s72 Amendment Officer Report

PA2101071-1

15 King Street, Dandenong

Section 72 Amendment Officer Assessment Report
Development Assessment

Figure 1 Comparison of approved floor plans and proposed amended floor plans

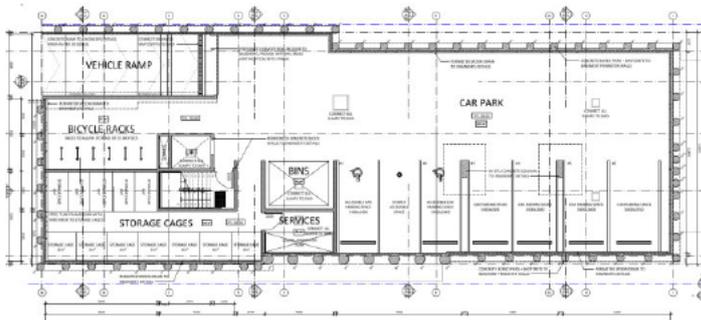
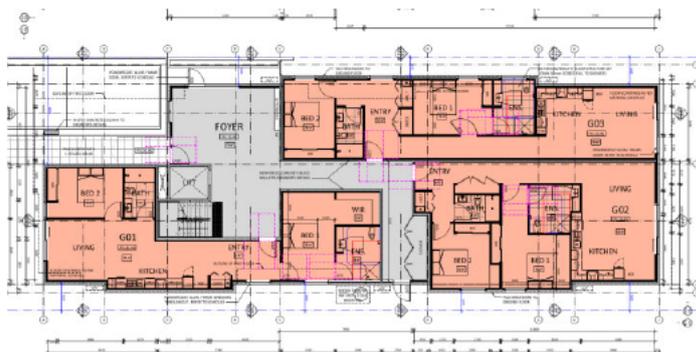
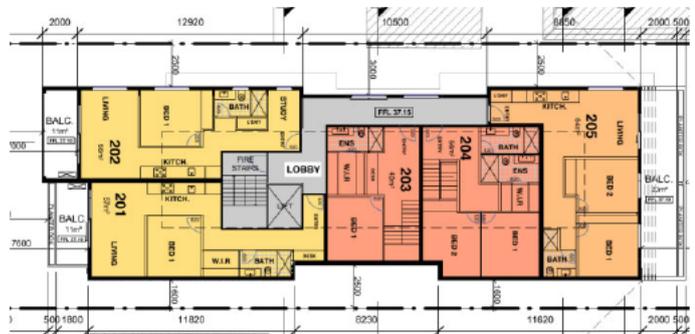
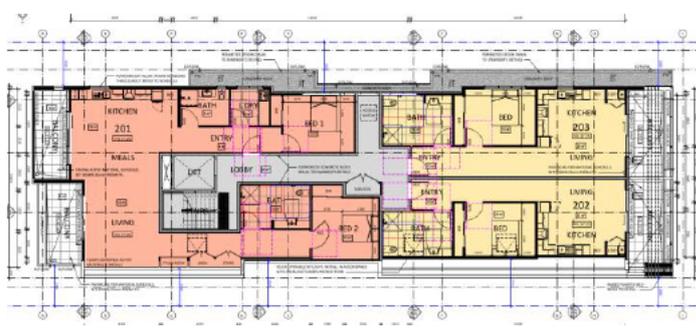
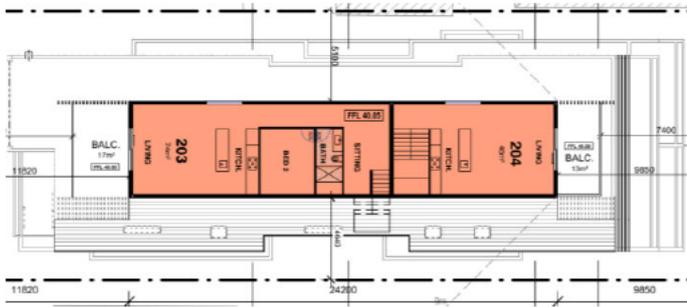
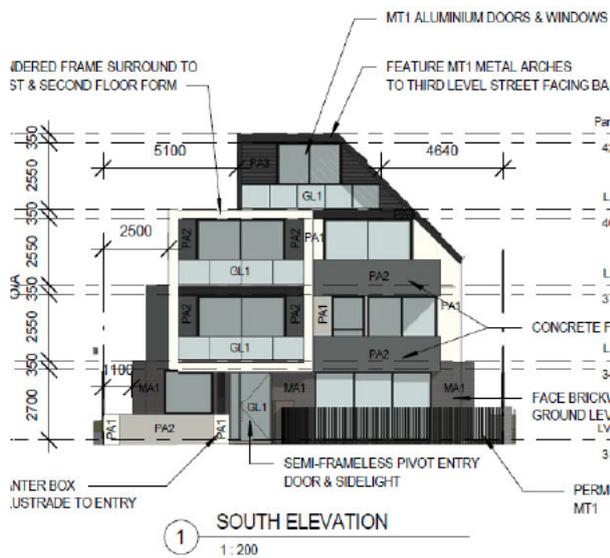
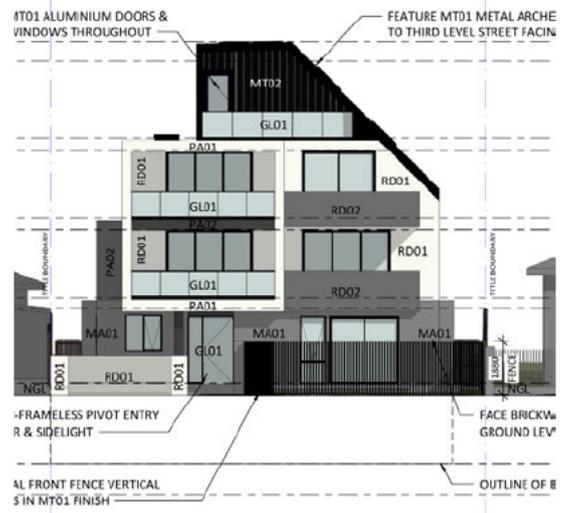
Generally, the proposed design response is similar to the approved built form, continuing to present as a four-storey, residential building. Various internal layout changes are required however to ensure units meet accessibility requirements associated with community care accommodation. Internal changes include:

Changes to building setbacks

Changes to levels

The basement carparking area has been amended to delete car parking stackers and reduce the overall provision of spaces from provide 6 car parking spaces, rather than 14 spaces previously approved.

Change / Comment	
Proposed Change	<p>Various changes to internal layout</p> <ul style="list-style-type: none">• Relocation of lift and internal stairwell• Reconfiguration of bicycle racks, storage cages and bin room storage on the basement level.• Reconfiguration of ground floor layout, including foyer, services, mailboxes, dwelling layouts and window locations/ sizes.• Ground floor eastern courtyard deleted, and eastern wall realigned.• Reconfiguration of first floor hallway, including deletion of window.• Minor reconfigurations of first floor dwelling layouts, including changes to balcony areas and location of windows.• Reconfiguration of second floor hallway.• Reconfigurations of second floor dwelling layouts, including changes to balcony areas and location of windows.• Reconfiguration of third floor to provide overnight, on-site accommodation unit. Minor changes to balcony sizes and window locations.• South facing, third floor balcony amended to communal open space area.

Change / Comment	
Proposed Change	<p>Various changes to building setbacks, reducing the following building setbacks:</p> <ul style="list-style-type: none">• Basement level minimum northern setback reduced from 5.6 metres to 5.2 metres• Ground floor foyer entrance northern setback reduced from 12 metres to 7.4 metres.• Ground floor eastern courtyard deleted, and eastern wall realigned from 4 metre to 1.6 metres setback in this area.• Second floor central portion western setback reduced slightly from 3 metres to 2.85 metres.• Portion of third floor eastern setback reduced from 4.64 metres to 4.50 metres.• Third floor minimum eastern setback reduced from 4.64 metres to 4.25 metres.
Assessment	<p>The proposed changes to building setbacks have been assessed and are generally considered acceptable.</p> <p>The reduced northern setback of the basement level is inconsequential and will have no additional impact adjoining properties or trees.</p> <p>Ground floor</p>

The amended third floor plan now incorporates a south facing communal balcony (setback 4.67 metres from eastern boundary), central circulation area (setback 4.25 metres from eastern boundary) and an overnight on-site accommodation unit (setback 4.5 metres from eastern boundary). The approved plans show a setback of 4.64 metres from the eastern boundary across this level. The amended plans show setback is considered minor, 14cm less than the approved distance. The central circulation portion of the third floor extends for approx. 5.48 metres and encroaches 39.5cm on the approved setback. The reduction to the setback is more significant in this area, however, is not considered detrimentally impact the amenity on the adjoining property at 17 King Street, which is shown to have a non-habitable room window only in this location and will continue to receive adequate solar access. Based on the above, the amended setbacks are recommended to be supported.

Figure 2 Comparison approved and amended elevation plans

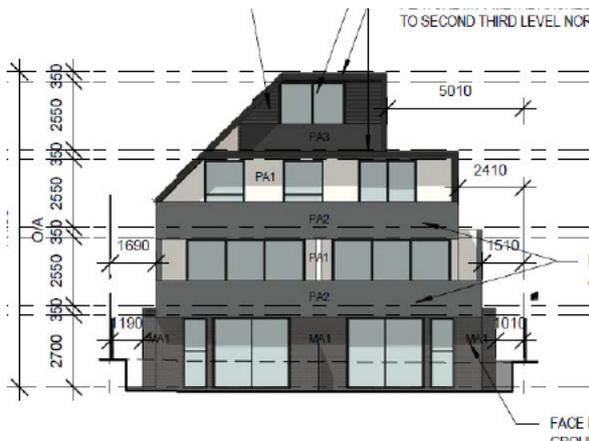
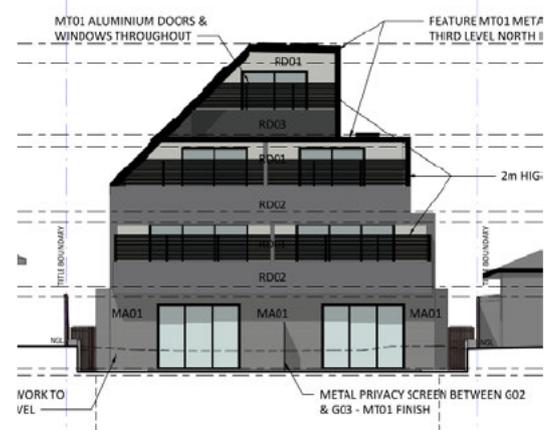
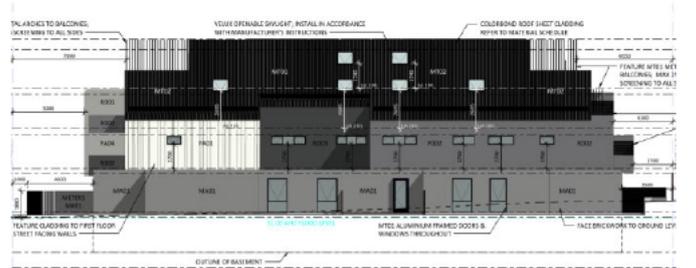
Metal screening added to north facing balconies to first, second and third floors. Screens to height of 2 metres, with maximum 25% opening.

Proposed Change	Various changes to buildings levels, including overall building height increasing from 11.75 metres to 12.1 metres (+350mm)
------------------------	---

Proposed Change	Metal screens added to northern, rear balconies.
------------------------	--

While some overlooking treatment is required to limit views from the identified balconies and comply with Condition 1(l) of the current planning permit, screening to a height of 2 metres exceeds the requirements of Standard B22 and is considered to unnecessarily reduce the internal amenity of these balcony areas for future residents. A condition on permit is recommended to reduce the height of these screens to 1.7 metres to sufficiently comply with the standard.

- Height of overlooking screens applies to north facing balconies reduced to 1.7 metres.
- Remove references to gas appliances and metres.

Figure 8 Overshadowing analysis 9am, 22 September - orange indicates extent of existing overshadowing

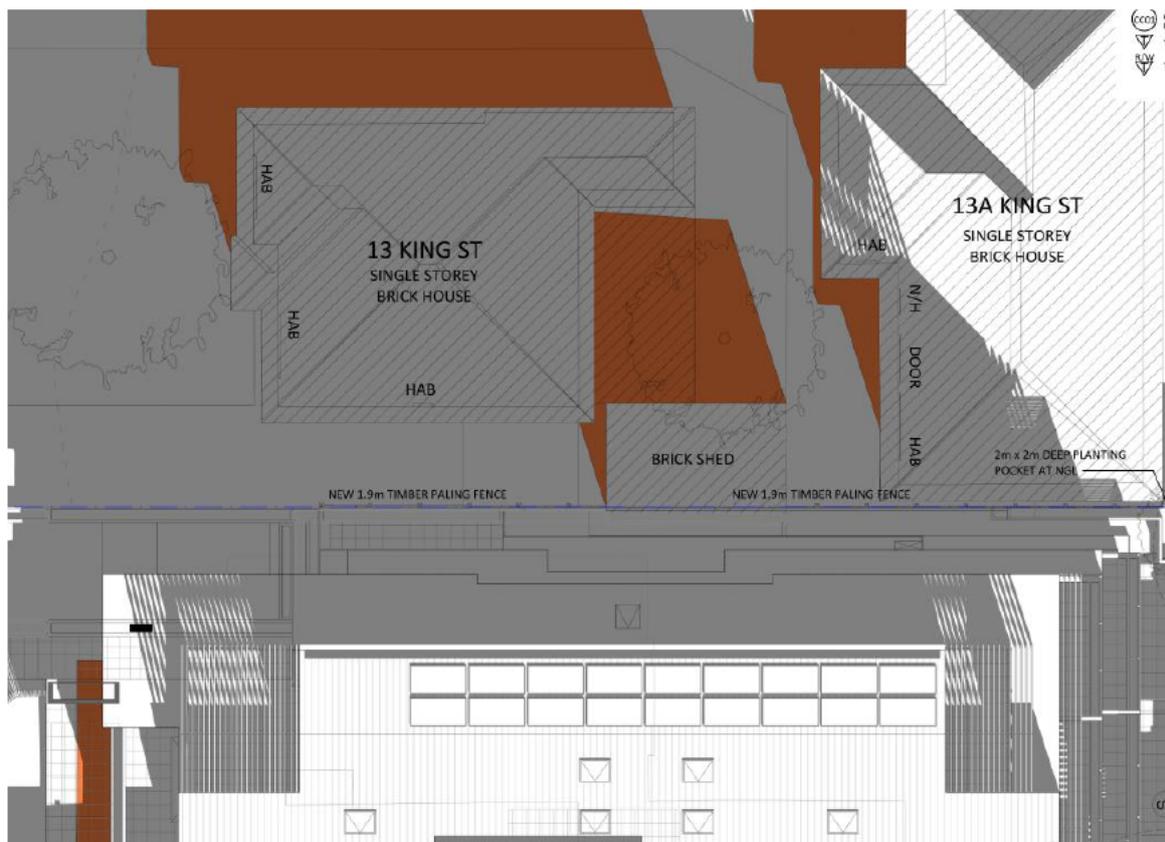
- *The submitted shadow diagrams do not represent the property at 13 King Street correctly. There is a sunroom at the rear of the dwelling which currently functions as a living space which is not clear on the plans.*

- *Our secluded private open space is approximately 40 square metres and there should be no increase to overshadowing of this area. The shadow diagrams at 9am and 10am show this secluded private open space will be fully overshadowed by this development.*

29. It is recognised the north facing habitable room windows at 13 King Street are not notated on the shadow diagrams submitted.
30. The private open space at 13 King Street is bounded by a brick shed to the east and paling fencing to the west and north, with an approximate area of 40 sqm and depth of 3.3 metres. The September 22 analysis demonstrates the proposed development will completely overshadow of the private open space at 9am, approximately 64% of the space at 10am and approximately 5.3% of the space at 11am. The area will not be overshadowed by the development for the remainder of the day. More than 75% of the private open space will receive sunlight between 11am and 3pm. While this does not achieve the 5 hours required by the standard, this variation is deemed acceptable given the extent of existing overshadowing of this area at 9am and 10am is caused by the brick shed adjoining the eastern boundary. Shadows cast by this outbuilding already impact 40% of this area at 9am, including overshadowing of the sunroom habitable windows (refer to figure 8).

31. The extent of overshadowing is marginally increased by approximately 4% at 10am compared with the shadow diagrams previously approved. The amended overshadowing extent is considered acceptable and does not constitute an unreasonable outcome beyond what was previously approved, noting the extent of overshadowing of this SPOS in the morning partially results from the existing outbuilding. The underlying Residential Growth Zone is also considered to be a relevant factor, noting this is an area where medium-density redevelopment is encouraged. On this basis, the variation to Standard B21 continues to be deemed acceptable.

Standard B17

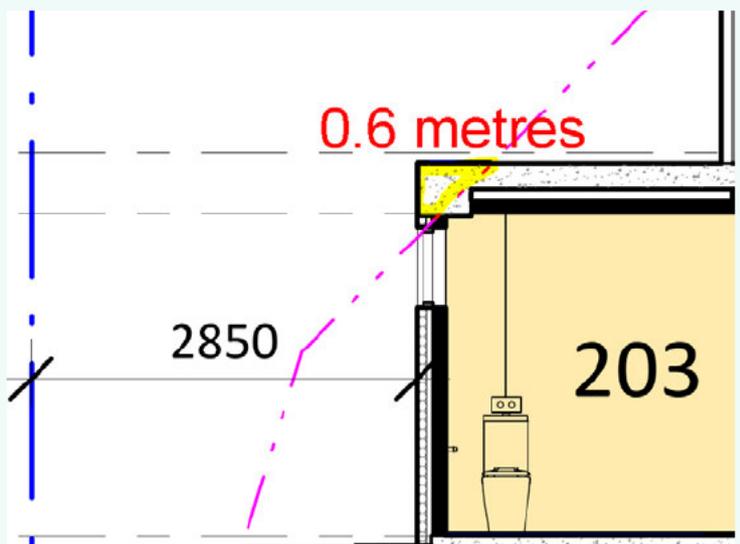
The amended plans continue to seek minor encroachment to the standard. The decision plans previously approved setback variation to a central portion of the second and third floor on the western elevation and portion of the second-floor roofline on the eastern elevation.

The amended plans show side setbacks which are largely consistent with those previously approved. There is minor reduction to the side setback in the central portion of the western wall at the second floor, reducing from 3 metres to 2.85 metres. The extent of encroachment to the standard previously approved on the second floor was approximately 53.5cm. Based on the reduced setback this encroachment is proposed to increase to approximately 56cm as shown:

The western side setback at the third floor remains 5.1 metres and no change to the approved encroachment to the standard is sought through this amendment.

Eastern setback

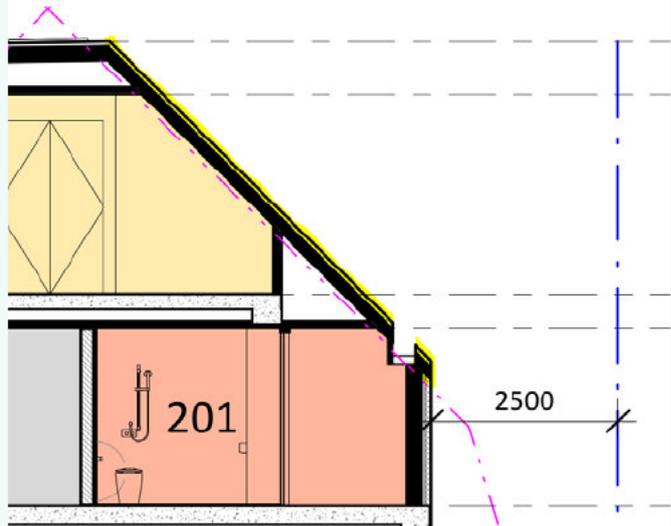
The amended plans show a minor reduction to the eastern wall setback at the third floor, reducing from 4.64m to 4.5m. There is also a small portion of the wall where the setback is further reduced to 4.24 metres adjacent to the services/ communal circulation area. The angle of the eastern roofline at this level follows the contour of the standard, however the reduced setback results in a minor encroachment of the roofline of approximately 40cm as shown:

This encroachment is very minor and is not anticipated to result in any noticeable visual impact or adverse impact to the adjoining property at 17 King Street. This additional variation is considered acceptable.
